## Product Change Notification / CAAN-27VKXJ630

CCB 6849 Initial Notice: Qualification of STA as an additional assembly site for selected AT42QT1x, AT42QT21, AT42QT41, ATmega16, ATmega32, ATmega48, ATmega8x, ATtiny26, ATtiny46, ATtiny8x, QT60160 and QT60240 device families available in 32L VQFN (5x5x1mm) package.

**PCN#: CAAN-27VKXJ630**

## ANAC

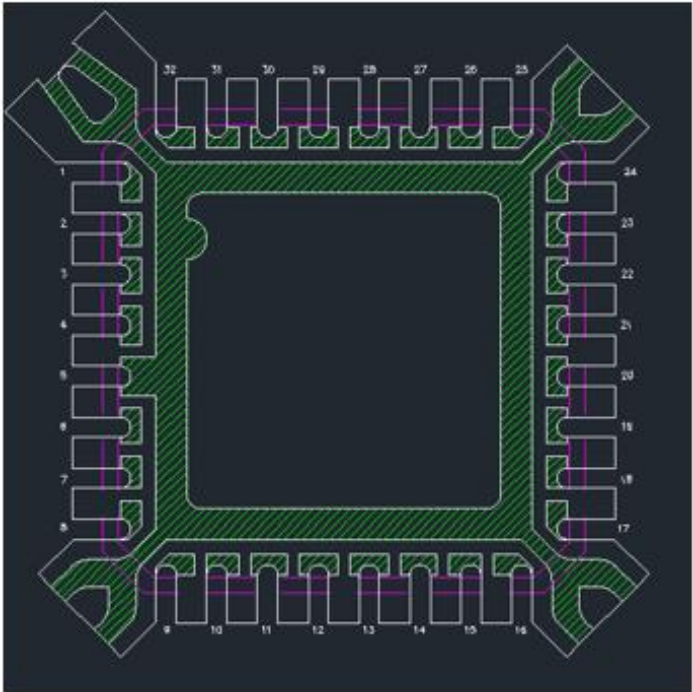
Wire Material	Au	CuPd
Lead-Frame Paddle Size	146X146mils	
Lead-Frame Material	C194	
Lead-Frame Lead Lock	No

## STA

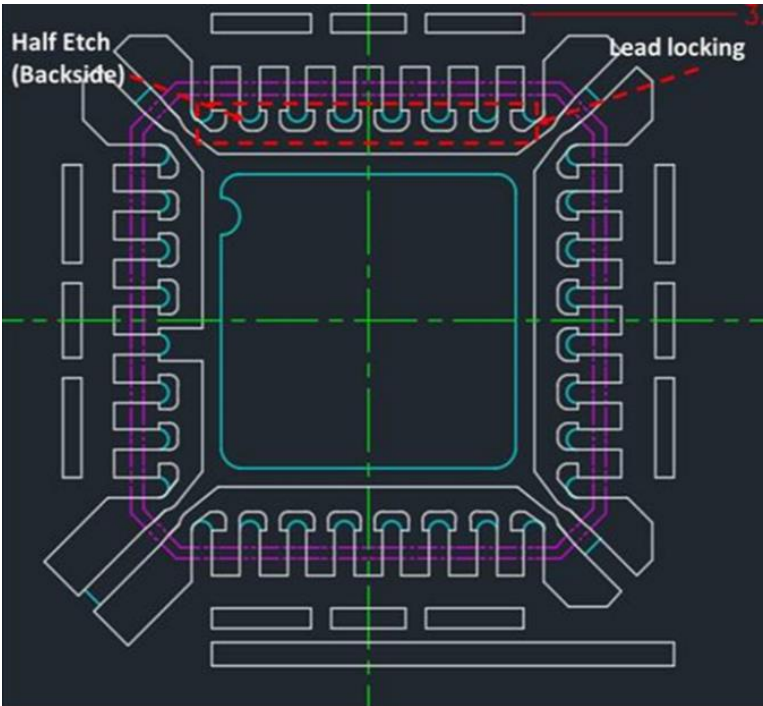
Wire Material	Au	CuPdAu
Lead-Frame Paddle Size	138X138mils	
Lead-Frame Material	C194	
Lead-Frame Lead Lock	Yes
